URGENT – FIELD SAFETY NOTICE

**GETINGE ED-FLOW AER, ED-FLOW SD AER
SOFTWARE UPDATE – Field Action 2016-01**

Date: August 16th, 2016

Field Correction Notice: Update the software to version 3.1.0

Duration of reprocessing cycle and product intake in an ED-FLOW or ED-FLOW SD AER

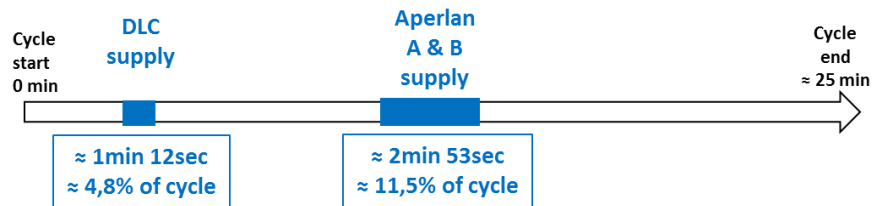
The issue we found can cause a lack of product supply (DLC detergent or Aperlan Poka-Yoke Agent A and Agent B disinfectant) if the compressed air supply of the machine is lost right before or during product supply, and after cycle start, and not re-established before cycle end (periods in blue on timeline).

This issue was raised during final testing of an ED-FLOW during the manufacturing process at the factory and we have not received any complaint related to this issue. **From our investigation, it was concluded that the probability of failure occurring is limited to a compressed air supply loss right before or during the product supply phases of the machine (about 4 minutes and 5 seconds).**

This potential for malfunction is caused by a design error in the software source code: the product supply function is wrongly conditioned by air presence. We have developed a new version of the software and removed this wrong condition in the source code. **In version 3.1.0, the product supply function is no longer conditioned by air presence.** The devices involved for your market are all Getinge ED-FLOW AER or ED-FLOW SD AER.

Resolution: Getinge proposes to update the machines to make sure all devices present on the market are working effectively and safely, by updating the software to version 3.1.0
